RIVER FOREST DEVELOPMENT REVIEW BOARD MEETING AGENDA

Subj: Lake and Lathrop Planned Development Application

Re: Planned Development Review
Revised Lake & Lathrop Mixed-Use Development

SITE PLAN / SET BACKS

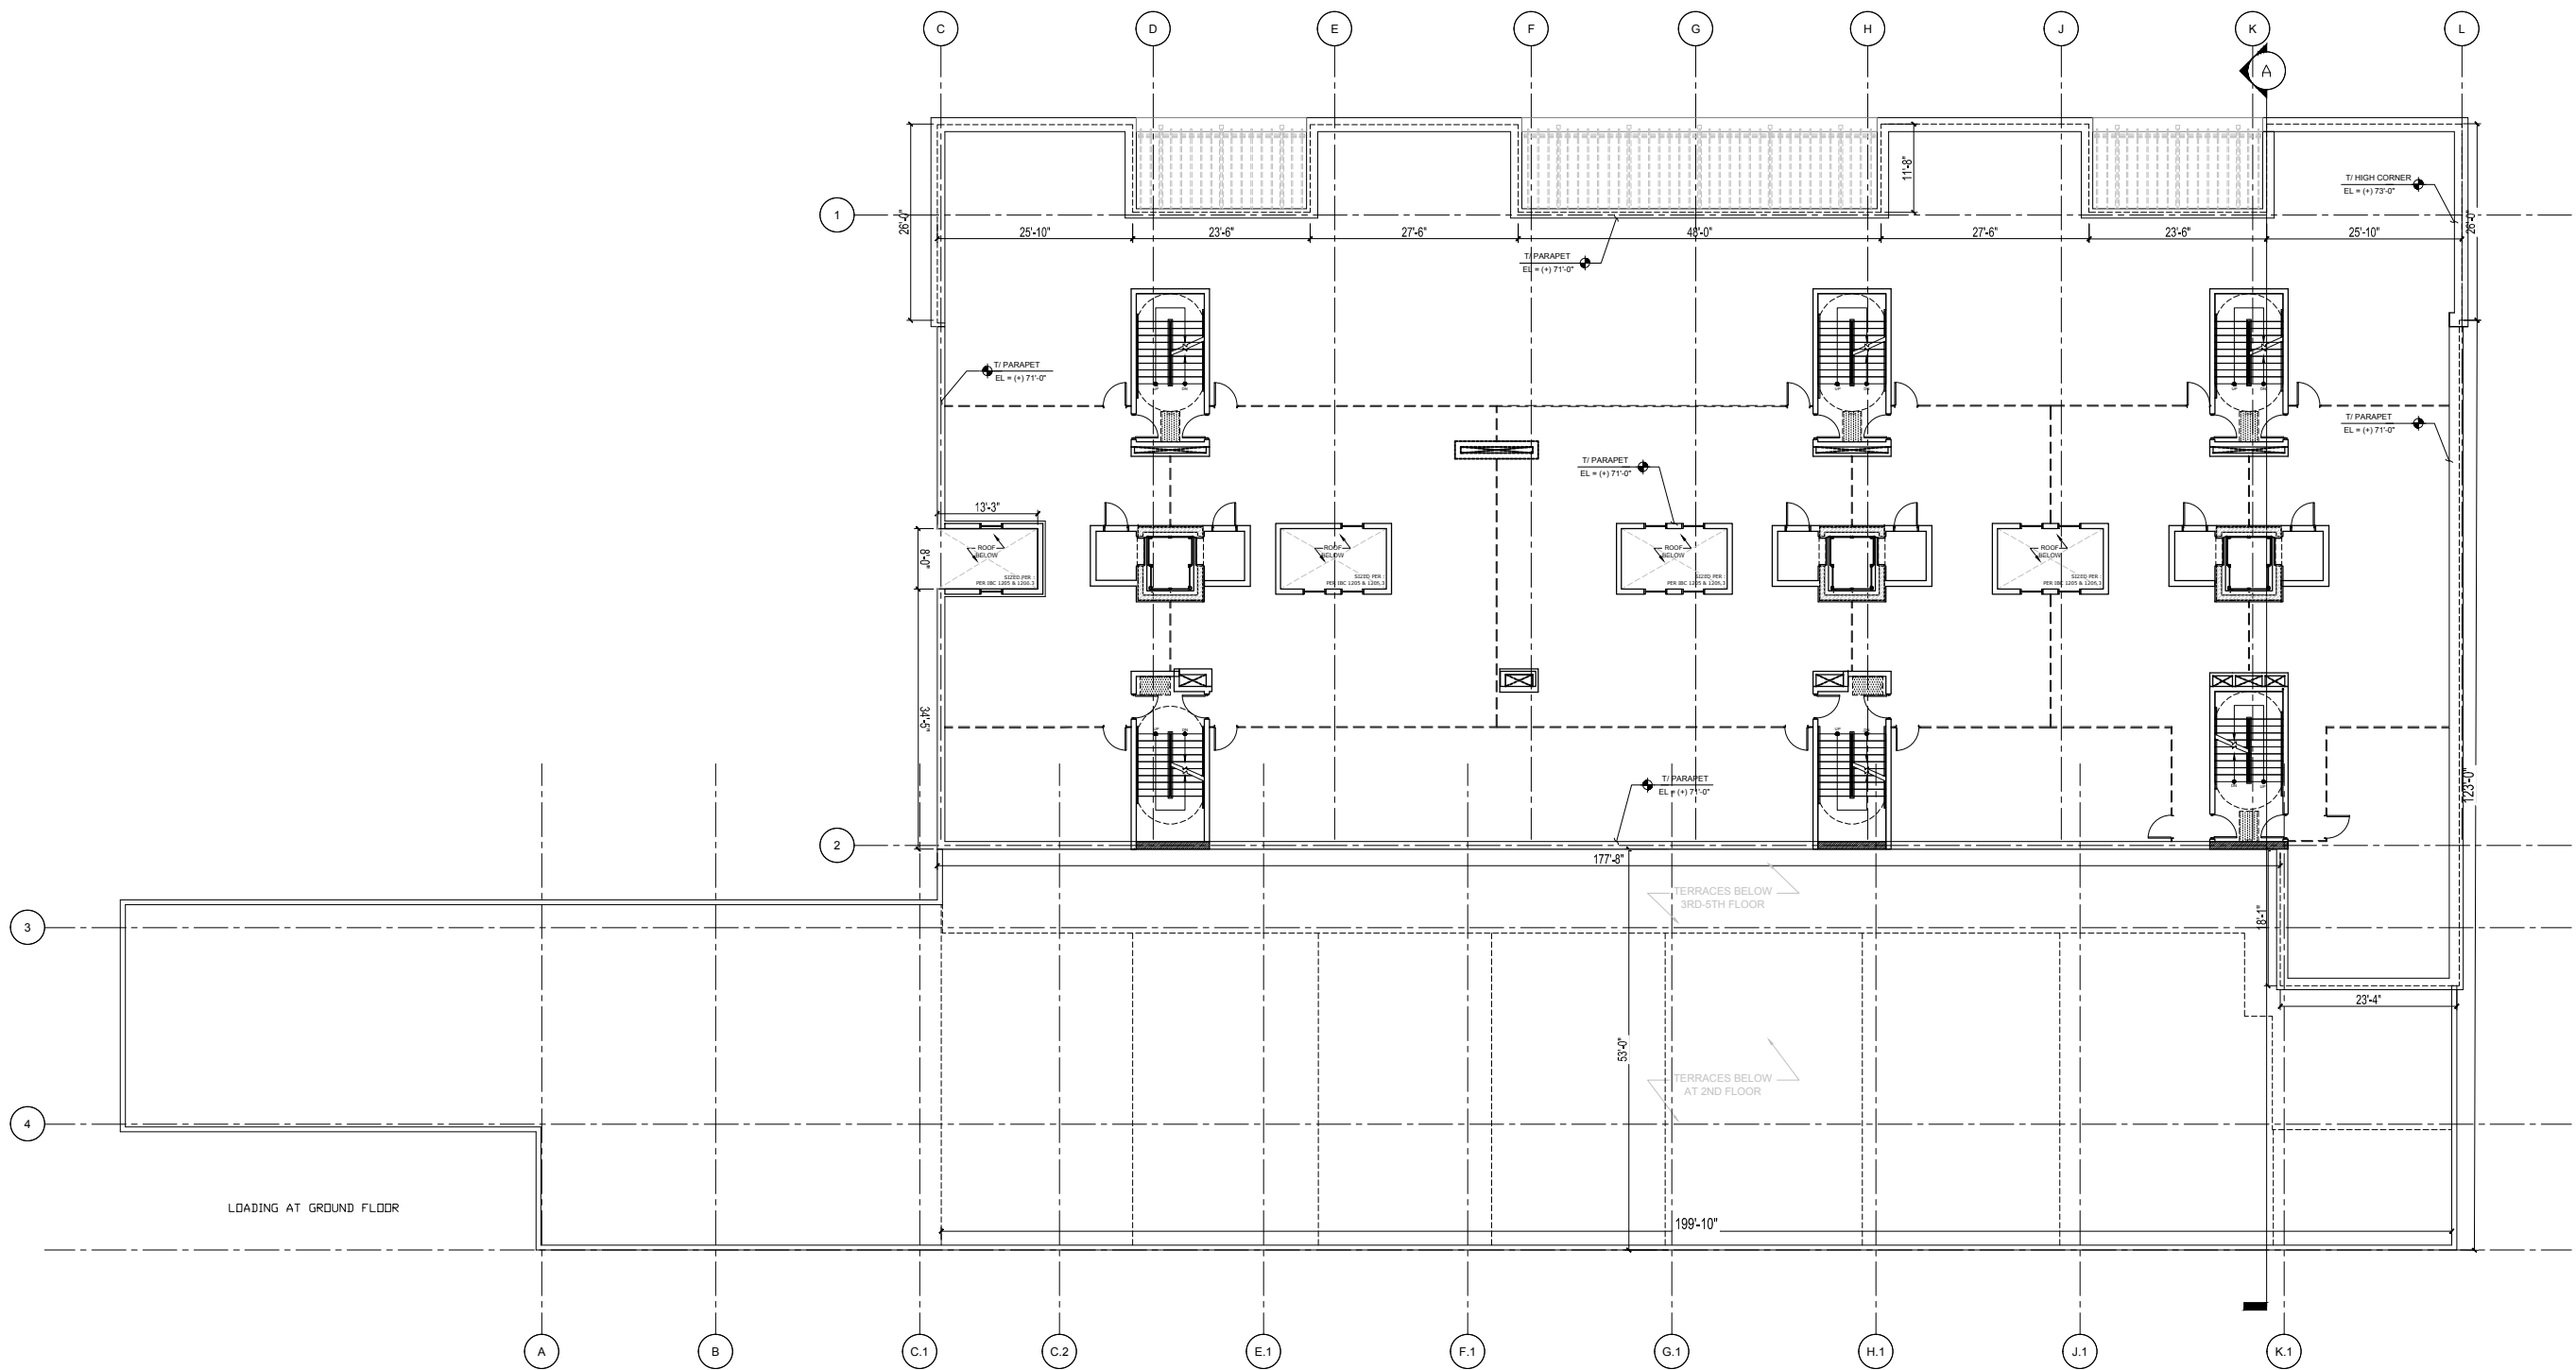
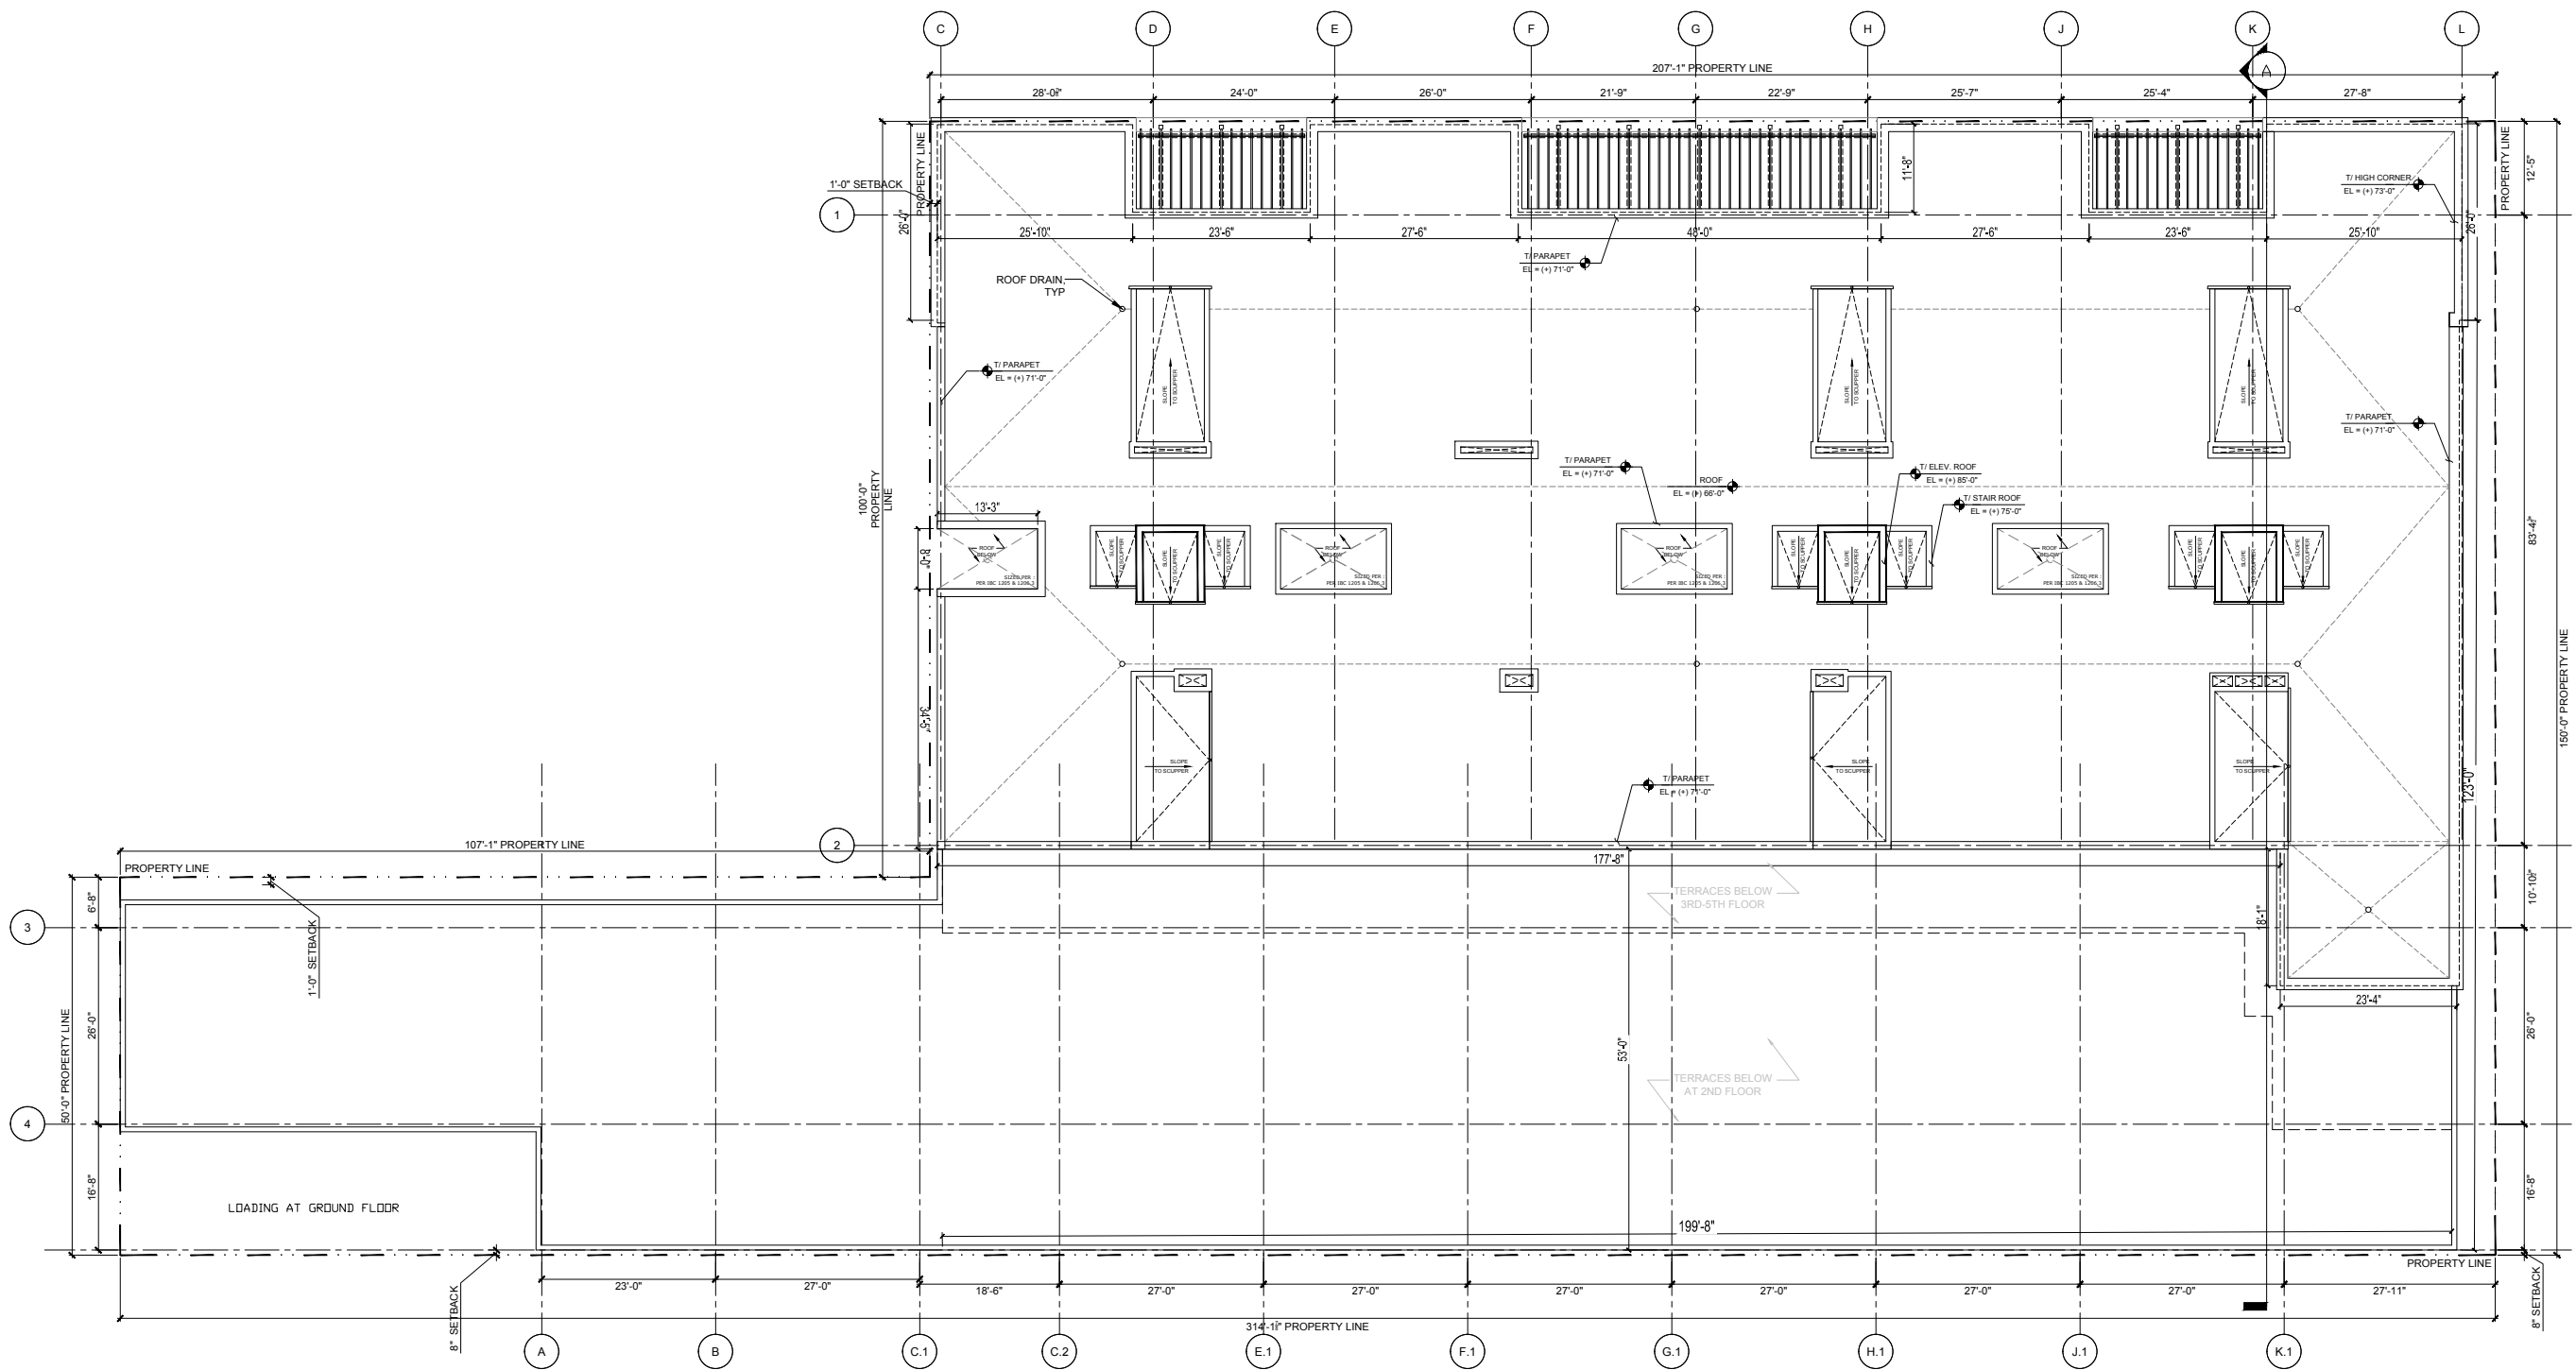
Although the height to the top of the parapet has been lowered 3', from 74' to 71', and the "high corner" has been reduced 7', from 80' to 73', the maximum height of the building has been increased from 80' to 85' to accurately accommodate the proposed stair and elevator overruns. These features are not located at the edge of the building and are therefore less visible than the parapet or exterior elevations of the building. However, these features (stair and elevator overruns) will be visible from certain ground floor perspective when approaching the building, as the features protrude 14' above the height of the parapet. Because River Forest measures the height of the building at its highest point, the proposed height for the development is 85' and will require a 35' SDA for height. The maximum height allowed in the C-3 District is 50'.

If all 86 parking spaces were designated for residents and their guests, the development would be compliant. However, the applicant is proposing that 32 parking spaces be designated for commercial uses, therefore leaving 54 parking spaces for residents and 0 parking spaces specifically designated for guests. Under this scenario, the development would require a 20 space SDA for resident parking, and a 6 space SDA for guest parking.

The proposed ***aisle width*** of 22' is less than the 25' required by code but will work for this project. A 3' SDA is required. Parking and circulation on an infill site can be challenging and a minor reduction in aisle width is reasonable. The Village has approved similar parking garage aisle width reductions in the past, provide internal circulation is not hindered. The internal circulation of the proposed parking garage is sufficient.

The proposed ***stall length*** is 18'. Code requires a stall length of 18.42'. The proposed stall length of 18' is appropriate and will meet the needs of the development. An 18' stall length has been approved for other planned developments in the Village and should be considered appropriate for this planned development.
